**Re: Cooley Reservoir and Fulton Wildlife Area, DRMS Permit No. M-1999-034  
Request for Compliance Status with Urban Drainage and Flood Control District Guidelines**

**Subject: CAMAS Colorado Inc., Cooley Reservoir and**  
**Fulton Wildlife Area Pit, File M-99-034**

# COOLEY RESERVOIR AND FULTON WILDLIFE AREA PIT

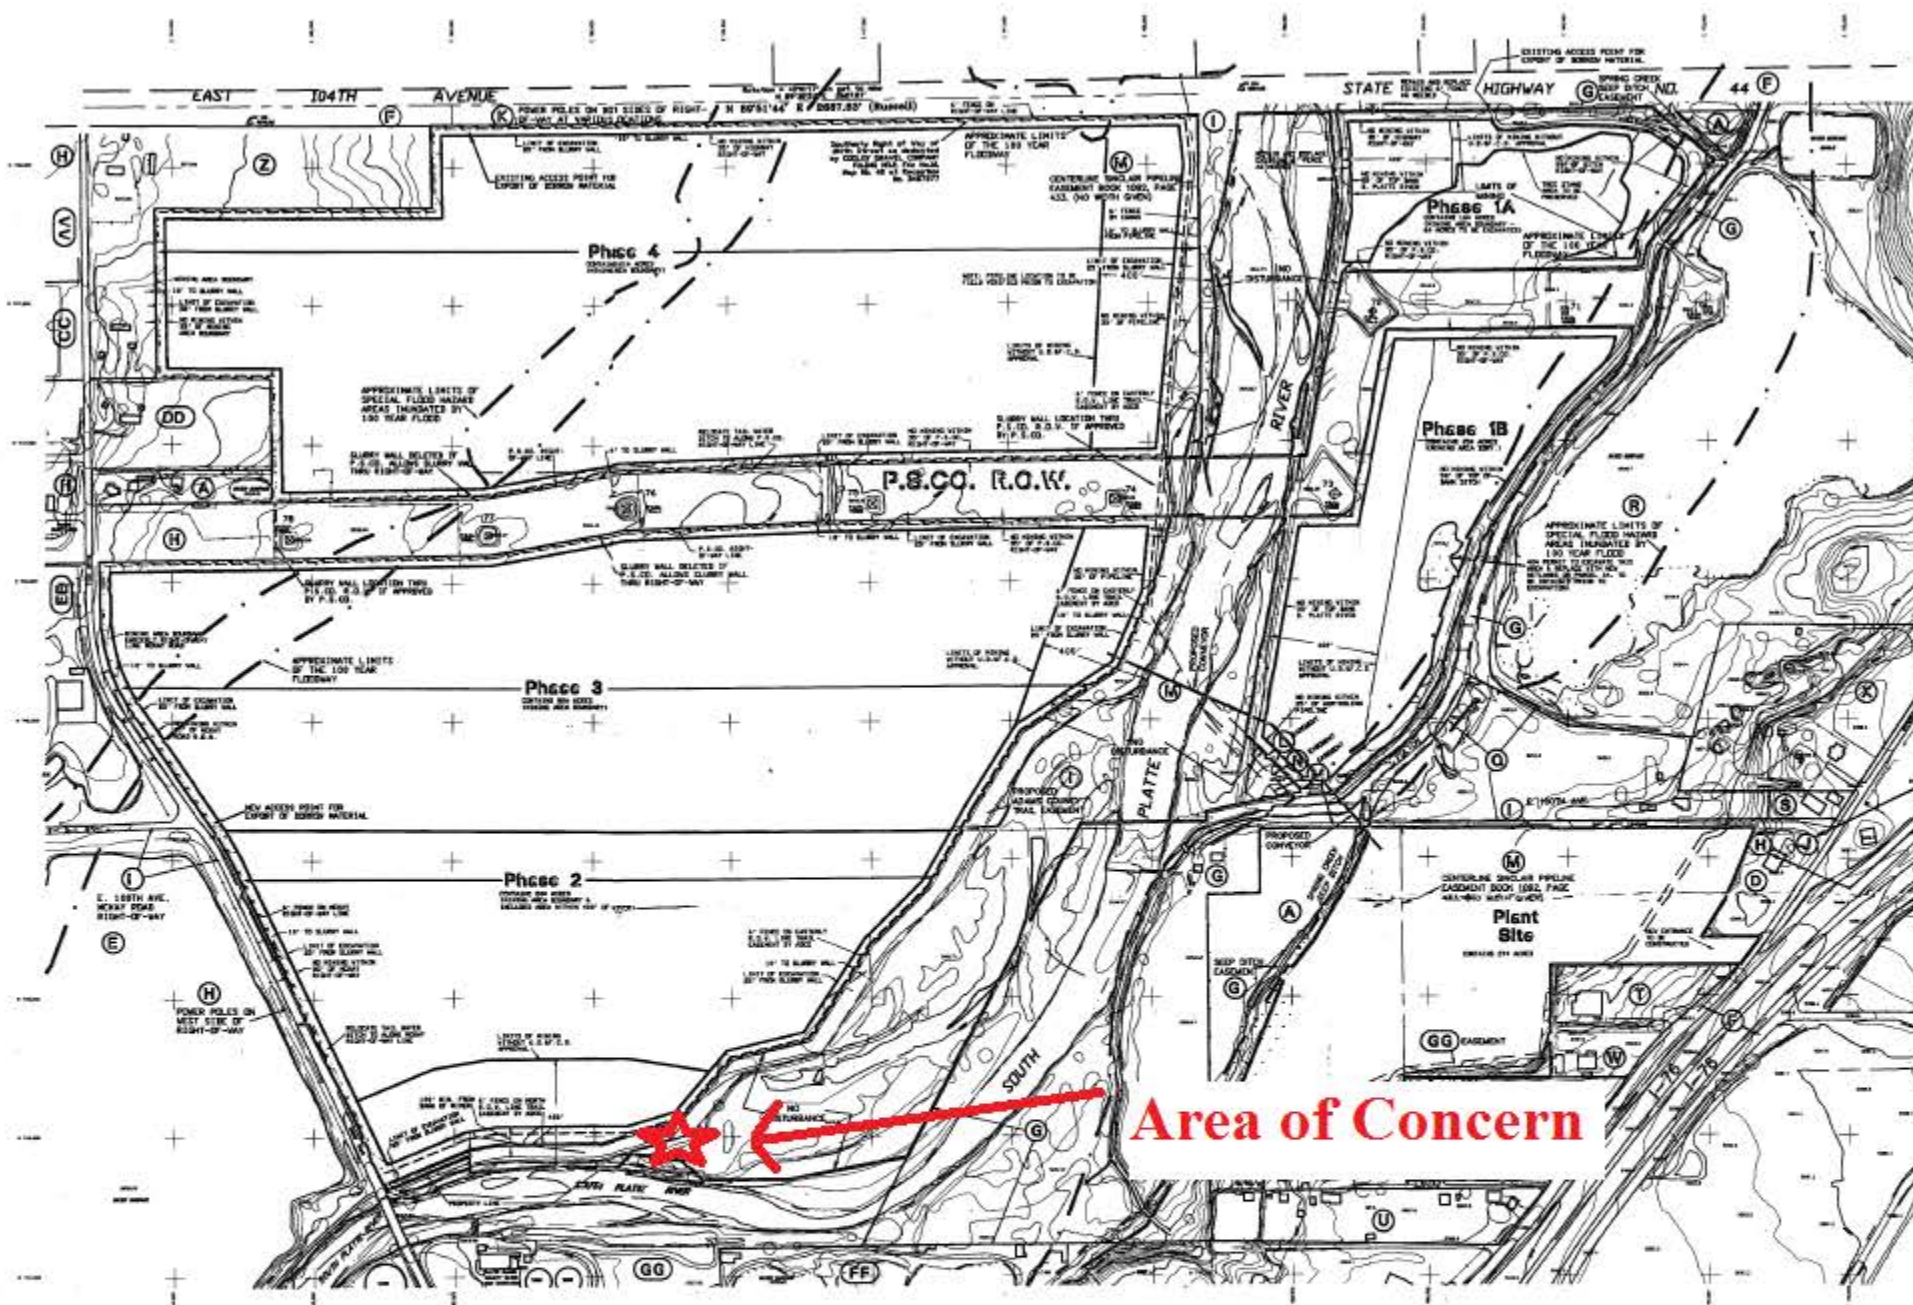
The Operator has already mined within the 400-foot setback from the River bank. In the southeast corner of Phase 2 (enclosed Mine Plan Map), mining activities were conducted within 200-feet of the River bank. The Operator informed the Division that approval from UDFCD had been secured prior to the mining activities within the 400-foot setback and that the Operator had conducted mining operations in compliance with the guidelines set forth by UDFCD. The Operator stated that only River side bank protection was required. The Operator also explained that the River side bank protection was installed by UDFCD as part of an easement agreement.

If a plan to mine closer than 200 feet was approved by UDFCD, could UDFCD please furnish, any documents regarding the design and approval of a 200-foot mining setback. If the 200-foot mining setback was not approved by UDFCD, could UDFCD provide to the Division any correspondence UDFCD had with the Operator regarding this matter.

1. The applicant has stated that no mining will occur within 400 feet of the South Platte River channel without approval by the Urban Drainage and Flood Control District (District). This is acceptable; however, the 100- to 400-foot setback limits are not properly shown on the plans. The setbacks have to be measured from the top of existing bank, or from the top of master plan bank, whichever is farthest away from the river. The plan needs to be revised accordingly before approval. I have enclosed a sketch of the 100- to 400-feet we feel is acceptable now. This is especially important along the west bank of the river at the McKay Road and 104th Avenue bridges. Preliminary plans call for new longer bridges. Therefore, the mining and reclamation setbacks need to start from the master plan channel bank alignment (i.e., proposed west side bridge abutments), not the 100-foot minimum setback as shown on Exhibit C-2.

2. On Exhibit C-2, Mining Plan Map, the Phase 1A and 1B areas show a note that reads "no mining within 35' of the top bank S. Platte River." The minimum setback allowed is 100 feet with both riverbank and pitside bank protection. A variance may be allowed if the applicant can guarantee that they mine and immediately reclaim the area within the 100-foot setback during one low flow season (generally October through March).
